Doc. Ref: HTR-FUW-EM-ZZ-PT-W-509-S5

**Application APP/20/0990 - Havant Thicket Reservoir
Application to Havant Borough Council for approval of a Non Material Amendment**

Extract from Illustrative Planning Strategy Key Plan to show design evolutions

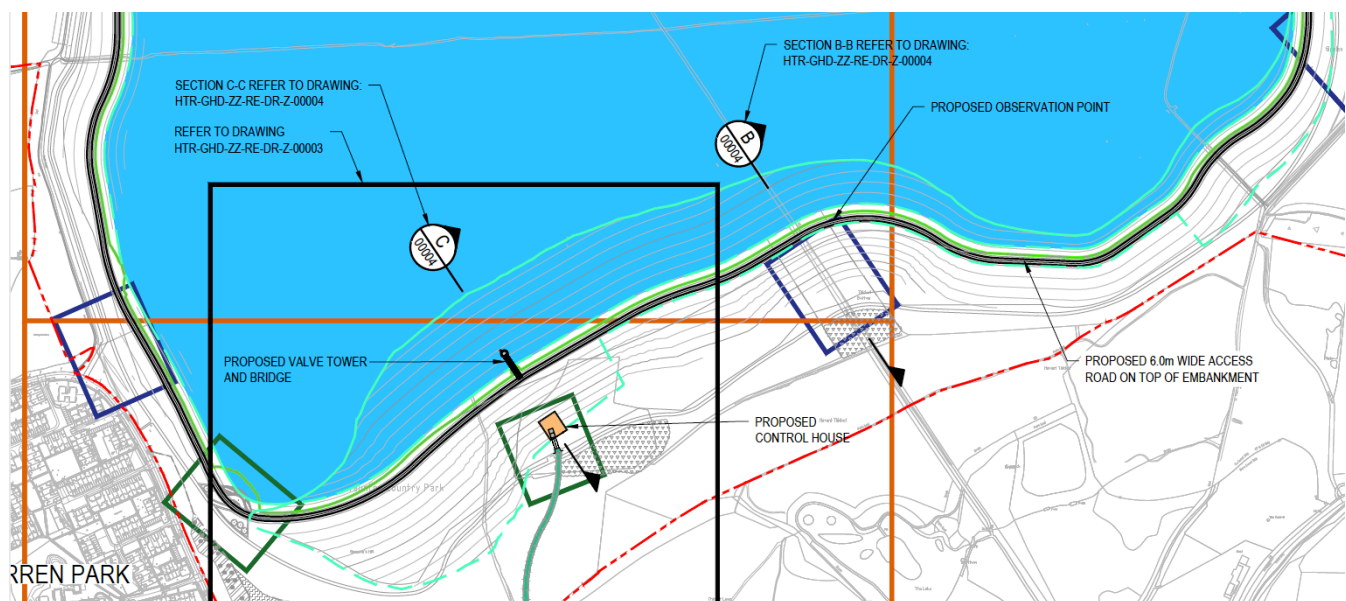
The consequence of the above, is that the detailed design for the main reservoir embankment will propose a change from the outline design in a number of respects. The changes relate to the southernmost embankment, as summarised as follows:

- Revised southern embankment position:
 - southern (external) toe moved further north near to the retained Ancient Woodland (away from the woodland by up to 19m – maintaining minimum 25m separation from the ancient woodland), and extended south in the south-west corner (to the west of the culvert and control house location)
 - northern (internal) toe moved further north as a consequence of the above by a variable distance
 - crest moved further north by up to 45m and extended in length to approximately 2,830m
- Slight increases to excavation and embankment earthworks volume, and small reduction in reservoir capacity but minimum capacity maintained at above 8,700 Million litres
- The embankment profile / gradients (both internal and external faces) remain as per the Hybrid permission (1:5 to 1:7 slopes)

In addition, as a result of the proposed earthworks embankment changes, other consequential changes will arise, with the location of the Valve Tower, Control House, Avenue Staircase and Viewing Platform moved to the north (by virtue of the embankment moving north).

The Figure below provides an illustrative update to the Planning Strategy Key Plan approved as part of the Hybrid permission, with the extract focused on the southernmost embankment to illustrate the design evolutions identified above. A full copy of the updated Planning Strategy Key Plan is available as separate Plan 1 enclosed with this letter.

Revised proposed location of Valve Tower and bridge

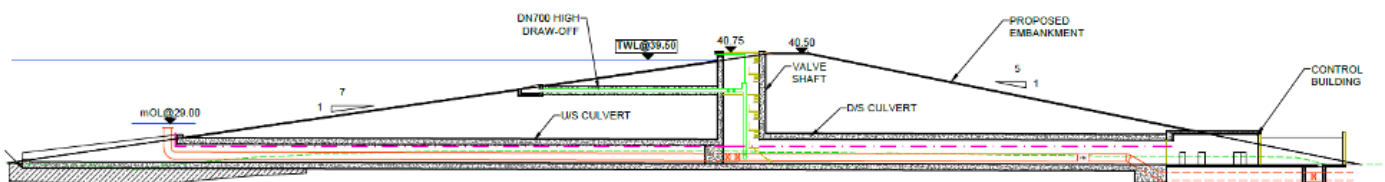
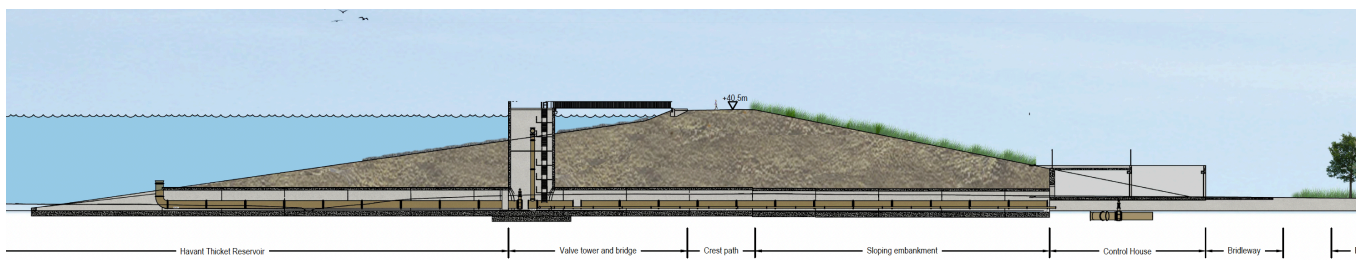
The outline design, which was the basis for the Hybrid planning permission secured the location of the reservoir culvert beneath the southern reservoir embankment, with the valve tower itself located within the embankment earthworks. An illustrative cross section through the southern embankment at the time of the Hybrid planning application showing the reservoir culvert, valve tower and control house is provided in the figure below.

As a result of the main reservoir embankment design evolution (referred to above), the whole of the reservoir culvert and valve tower need to move to the north, as the main reservoir embankment moves to the north.

In addition, as part of the detailed design of the reservoir culvert and valve tower, the design has evolved from that approved as part of the hybrid planning permission, as a result of knowledge and experience gained from the construction of the trial earth embankment, and from more detailed engineering design work. The most notable proposed design evolution is for the valve tower structure to be moved further to the north, outside of the core of the reservoir earth embankment but still within the embankment. This results in the valve tower becoming a more visible structure within the reservoir, albeit one that is seen in the context of the nearby main reservoir embankments. As part of the valve tower will be a structure within the water of the reservoir, there will also be a need for an operational pedestrian bridge to be provided between the crest of the embankment and the valve tower, for operational access for inspection and maintenance. This pedestrian bridge would not be open to public access, and suitable safety gate and fencing will need to be designed into the structure for health and safety reasons.

The consequence of this design evolution can be seen in the Figure below, which provides a cross section through the proposed embankment to illustrate the location of the reservoir culvert and the valve tower and related bridge. It can be seen that as a consequence of the main reservoir embankment moving to the north, and the design evolution for the reservoir culvert, the valve tower moves approximately 48m to the north.
